Project: Ketchikan Shipyard Medium Voltage
Loop

Solicitation No.: 19014

Addendum No. One

Question 23

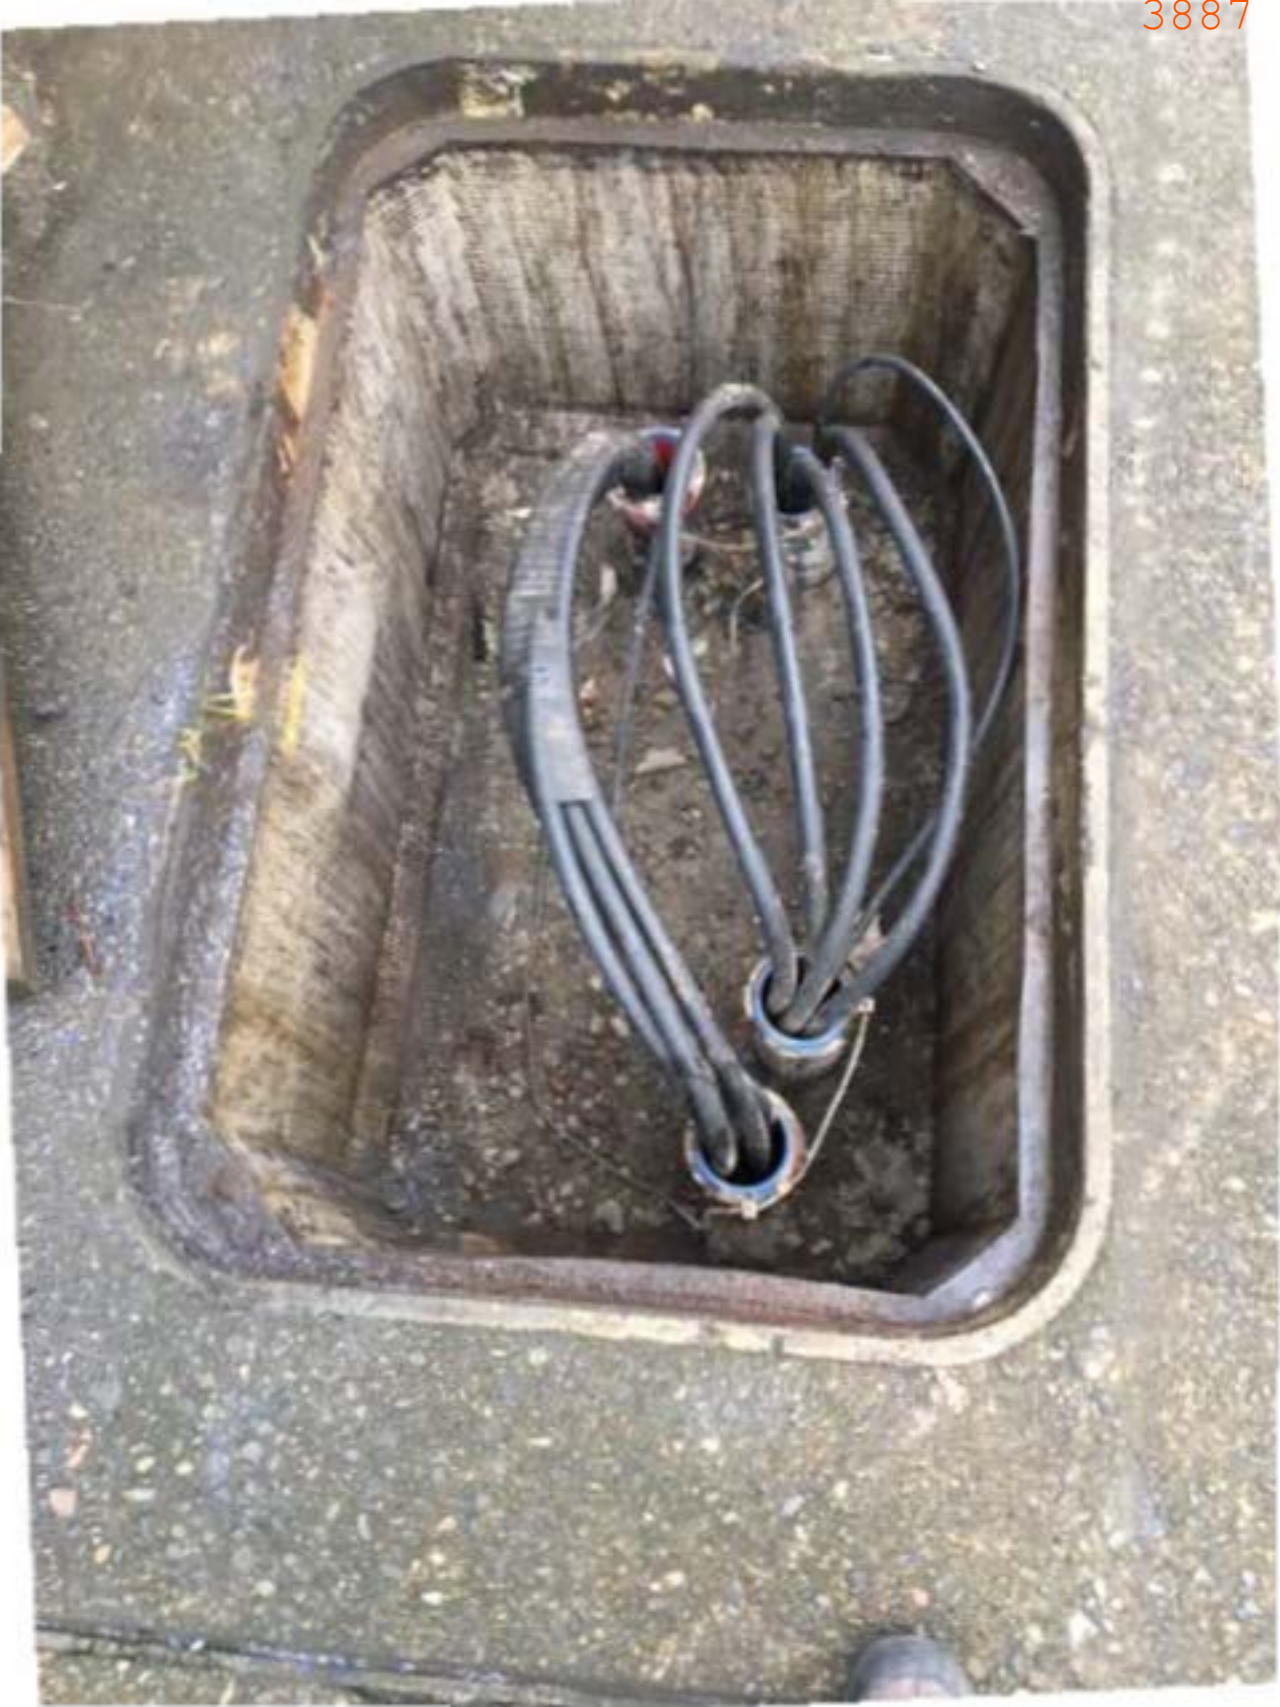
23) **Q:** Can you provide photos of the vaults?

A: They are attached, description is as follows:

- Photos 3884 and 3885 are the electrical one directly east of the paint/blast booth East of P7.
- Photos 3886 & 3887 (Handhole) electrical on the north east corner of machine shop feed to P6
- Photo 3889 EHM 2, electrical in the roadway NE corner of machine shop
- Photo 3890 EMH 5
- Photo 3891 & 3892 Comm's vault adjacent to EMH 5
- Photo 3894 Conn's vault adjacent to "E" vault at the NE corner against Tongass ave.
- Photos 3896 & 3896 "E" vault at the NE corner against Tongass ave. (Note, this is the vault with power feeder to KPU Maintenance Building)

Addendum One

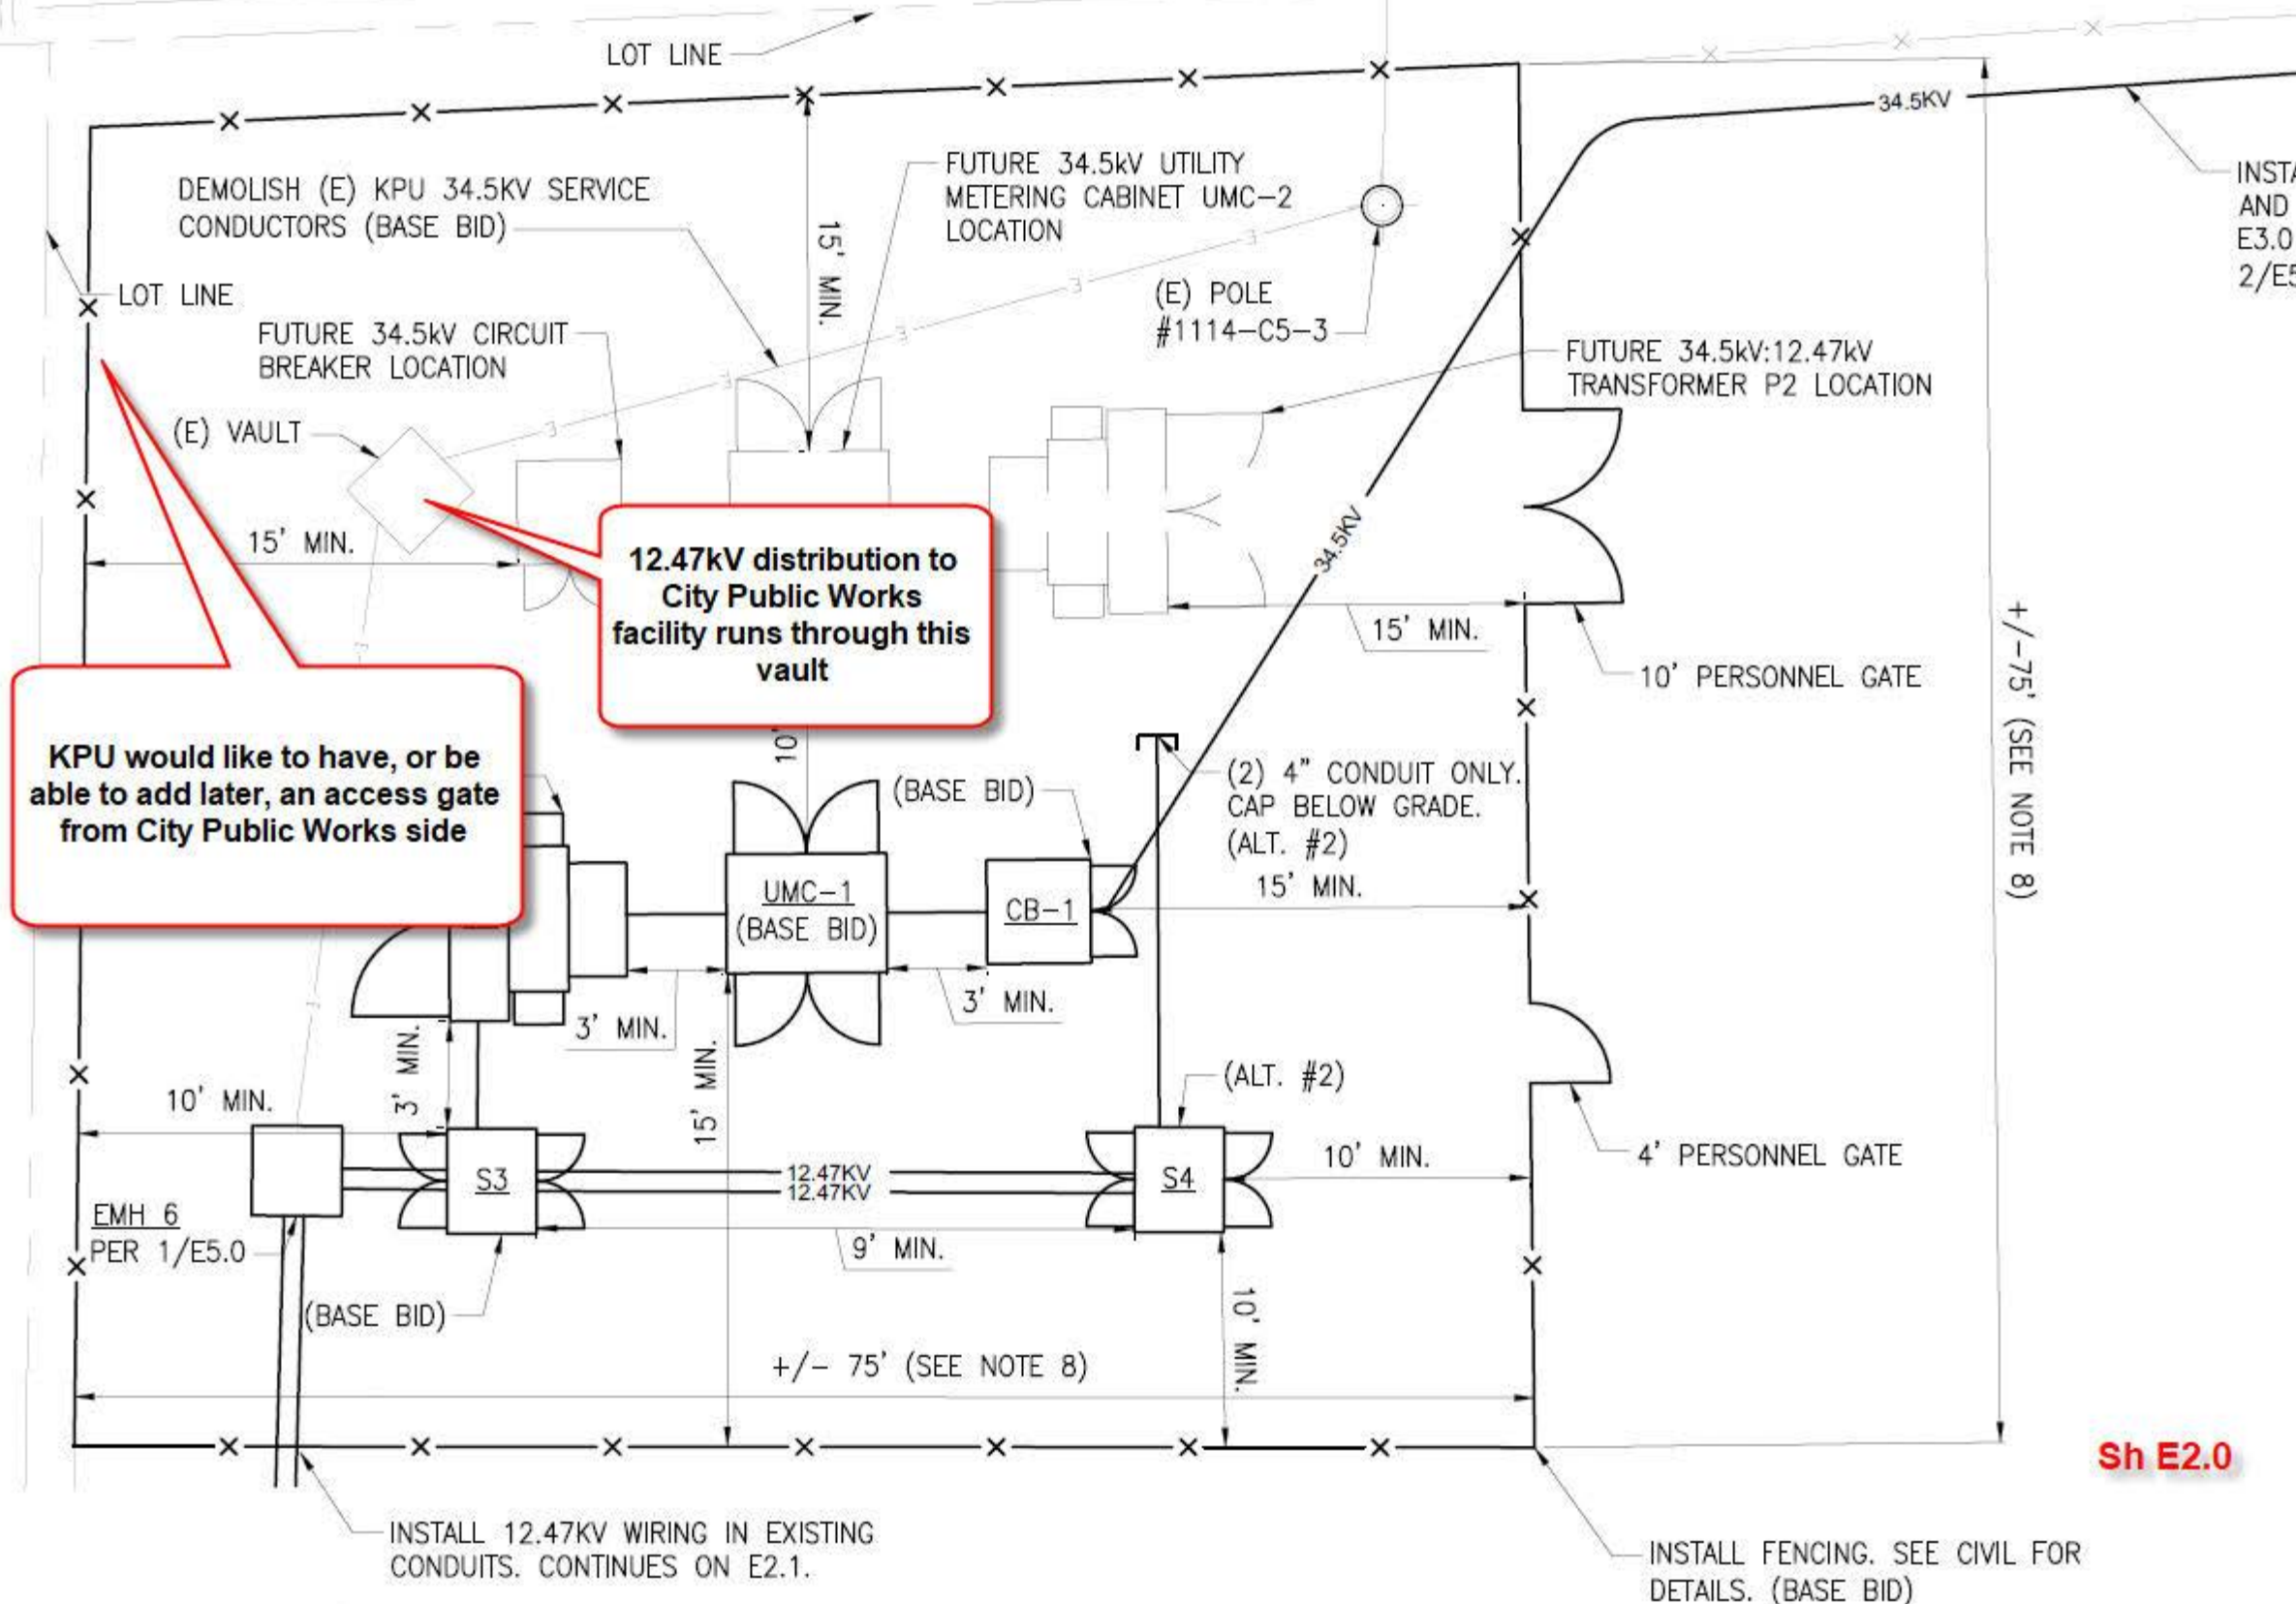
- 21) **Q:** E3.0 34.5 is on top of pole. Existing pole will need to be modified for new arrangement. Is this contractor scope or KPU. Current is alley arm and would require tree removal.
A: For bidding purposes Contractor shall assume they will modify pole as required to match detail provided. Assume trees shall be removed by others. Contractor coordination with KPU as required. Assume No impact to 15 kV. KPU has been contacted about possibly a different modification which will be resolved after the bid if required. (Photo attached)

KPU would like to have, or be able to add later, an access gate from City Public Works side

12.47kV distribution to City Public Works facility runs through this vault

**KETCHIKAN SHIPYARD MEDIUM VOLTAGE LOOP
 3801 N. TONGASS AVENUE
 ENLARGED PLAN - MACHINE SHOP AND AIR
 COMPRESSOR BUILDING**

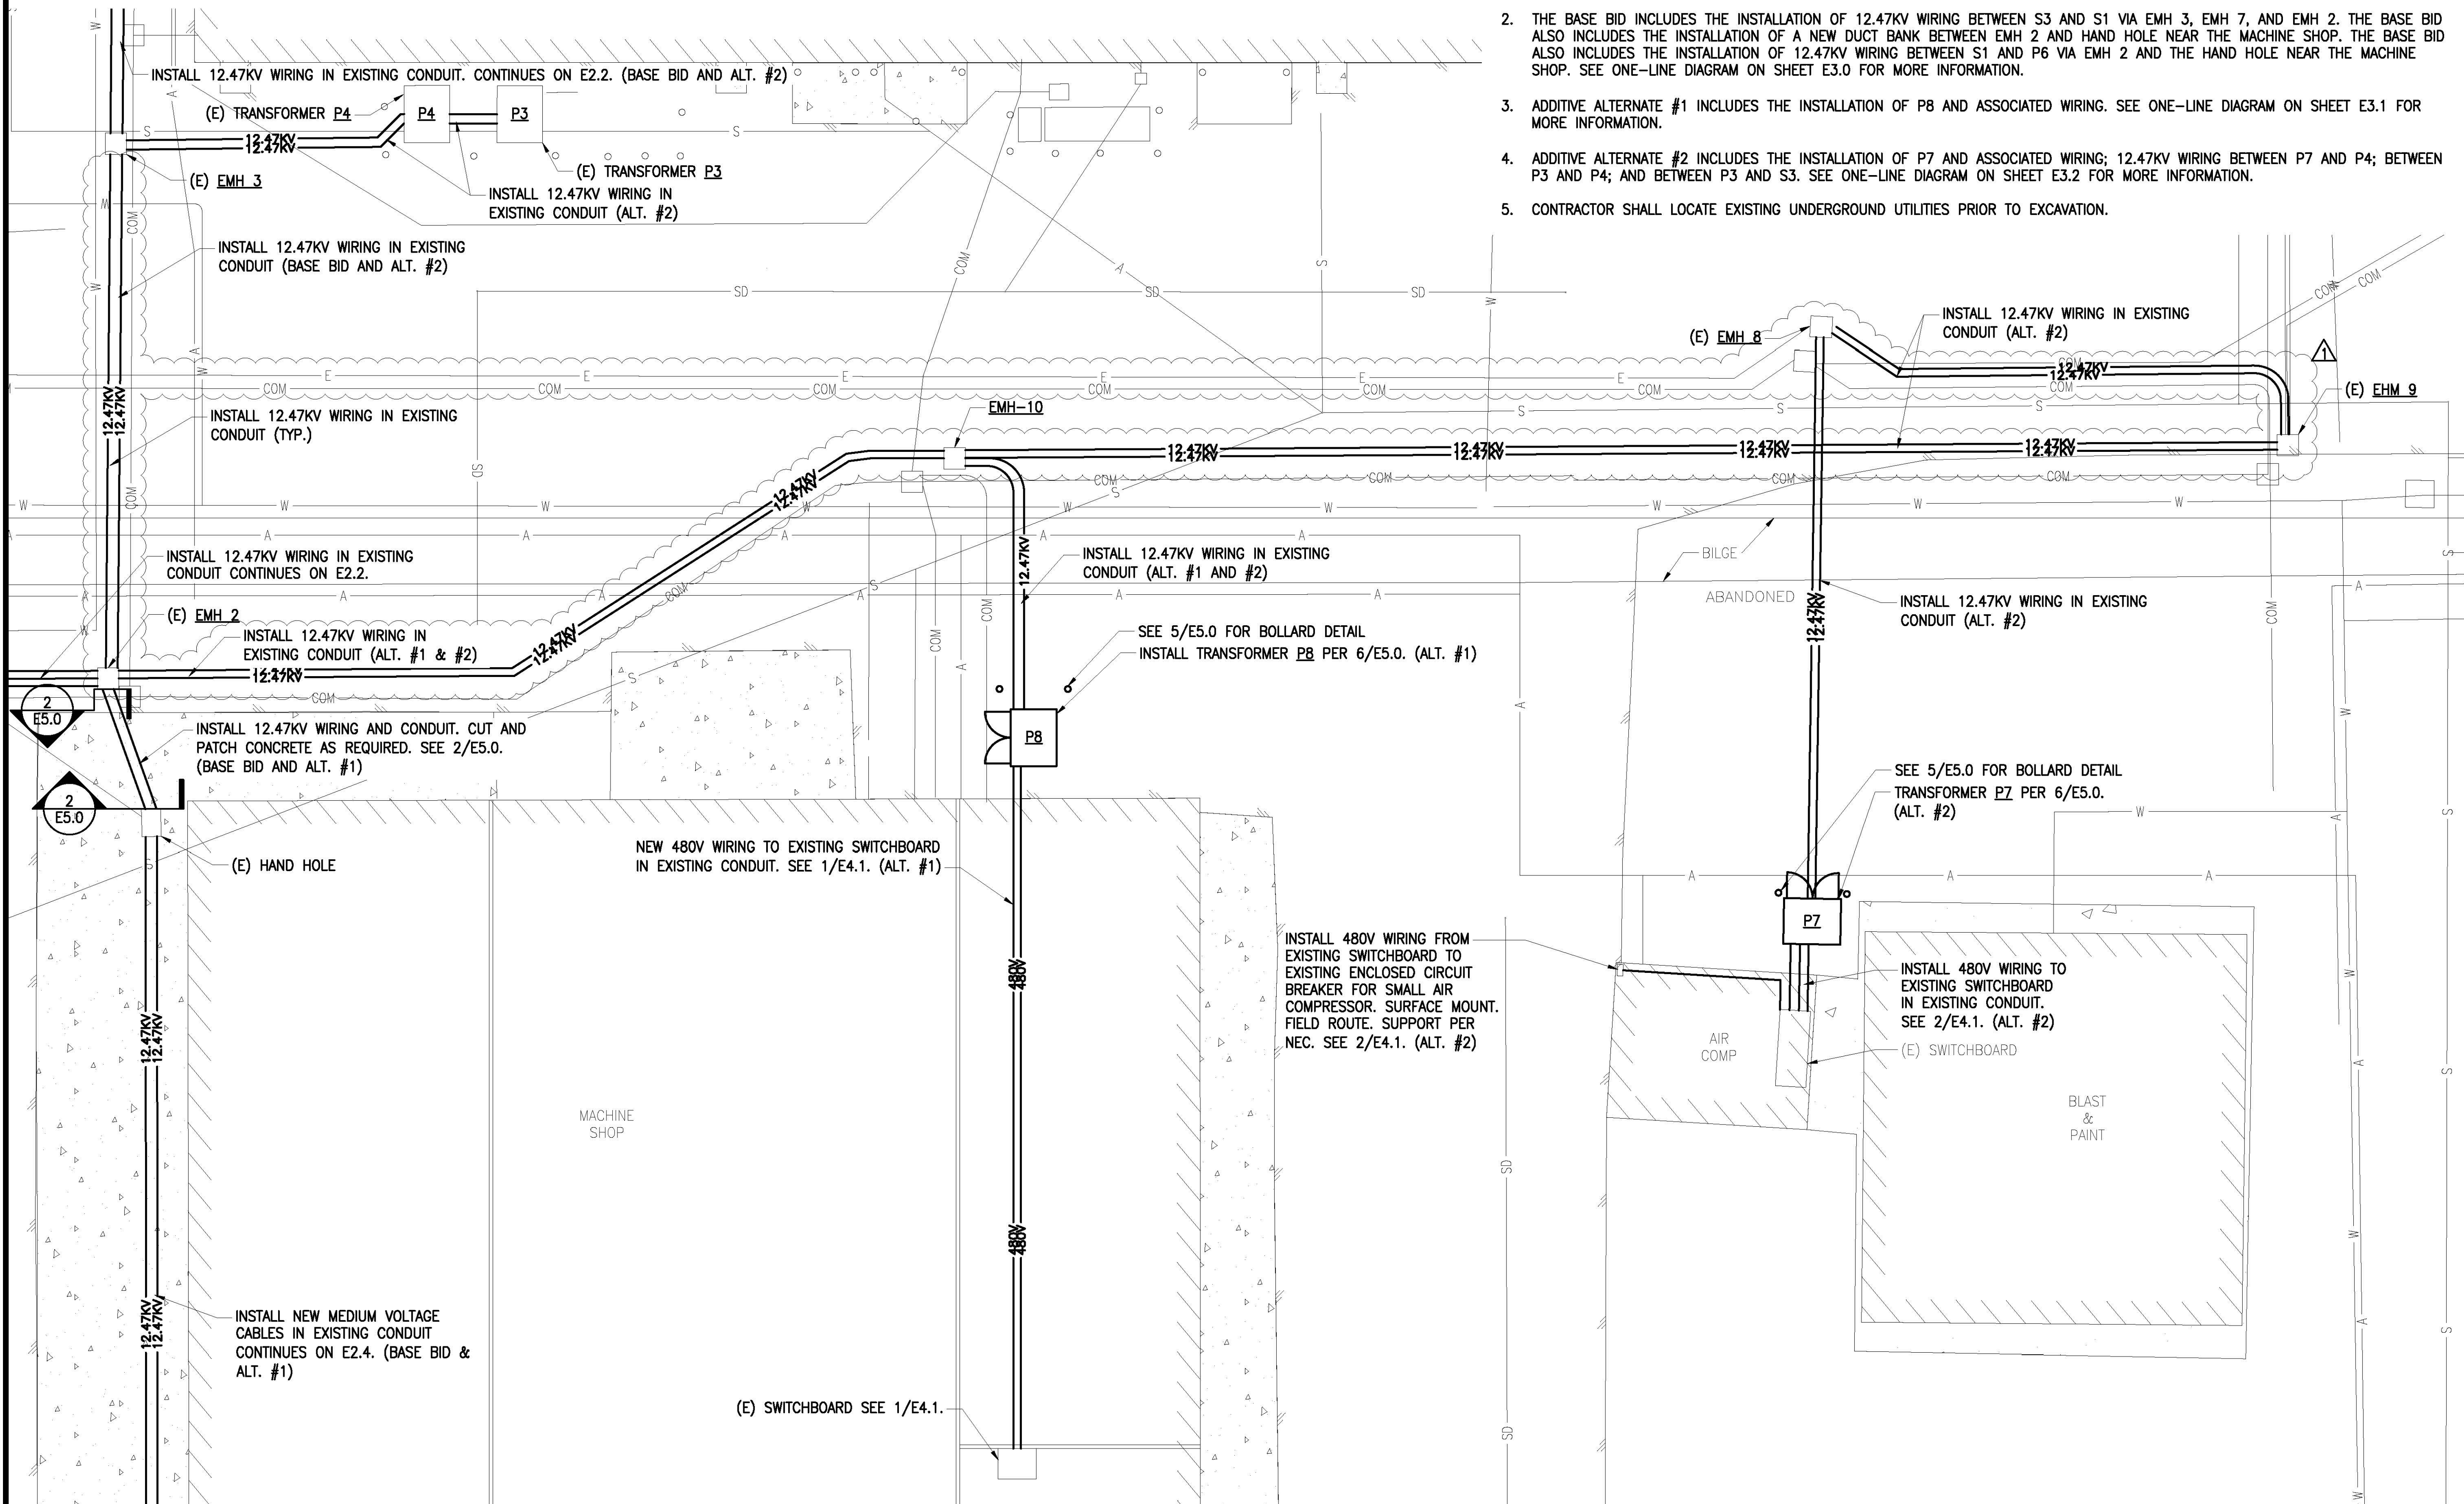
- 4) **Q:** 5/E5.0 Can plastic covered steel bollards be used?
A: Plastic covered steel bollard are an acceptable substitution to painted steel bollard
- 5) **Q:** Based on site visit is EMH7 existing?
A: No. See attached revised drawings.
